REFERENCE:	TSB: 07-002-25 REV. B GROUP: 07 - Cooling	Date:	June 7, 2025	REVISION:	07-002-25 REV. A
VEHICLES AFFECTED:	<p>2024 - 2026 (B1) Jeep Renegade 2025 - 2026 (H1) Jeep Commander 2025 - 2026 (M1) Jeep Compass This bulletin applies to B1 vehicles built on and after July 10, 2024 (MDH 0710XX) and on or before January 30, 2025 (MDH 0130XX) equipped one of the following:</p> <ul style="list-style-type: none"> **1.3L I4 Turbo MAir DI Engine (Sales Code EYH).** 1.3L I4 Turbo MAir DI Engine w/ESS (Sales Code EYF). 1.3L I4 Turbo Mair DI Eng w/ESS E100 (Sales Code EYJ). <p>This bulletin applies to H1 vehicles built on and after July 09, 2024 (MDH 0709XX) and on or before January 14, 2025 (MDH 0114XX) equipped with one of the following:</p> <ul style="list-style-type: none"> **1.3L I4 Turbo MAir DI Engine (Sales Code EYH).** 1.3L I4 Turbo MAir DI Engine w/ESS (Sales Code EYF). 1.3L I4 Turbo Mair DI Eng w/ESS E100 (Sales Code EYJ). <p>This bulletin applies to M1 vehicles built on and after July 09, 2024 (MDH 0709XX) and on or before January 07, 2025 (MDH 0107XX) equipped with one of the following:</p> <ul style="list-style-type: none"> **1.3L I4 Turbo MAir DI Engine (Sales Code EYH).** 1

Fig. 1
Inspection Area

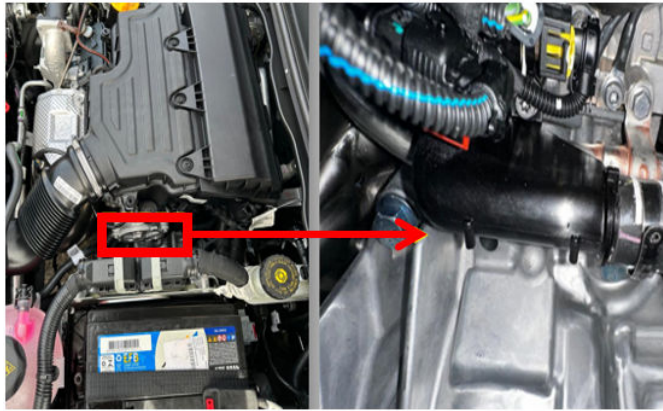
3. Inspect the thermostatic valve and it surrounding area for evidence of leaking coolant [Fig. 1](#).

Fig. 3
Thermostatic Valve With Gasket

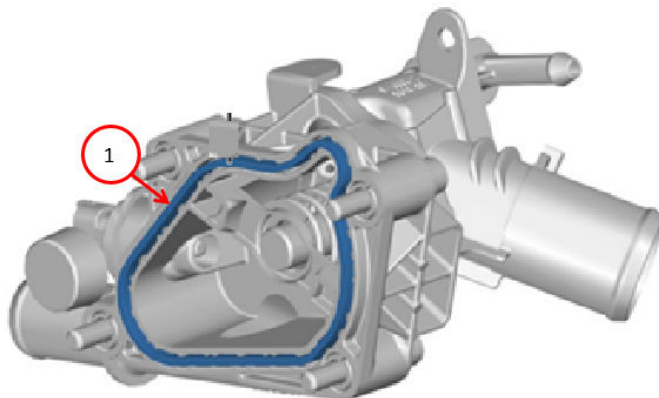
1. Remove the thermostatic valve and replace the thermostatic valve gasket [Fig. 3](#). Refer to the detailed service procedures available in DealerCONNECT/Service Library under: Service Info> 1088C40 - Thermostatic Valve - Removal/Replacement - Including necessary procedures.
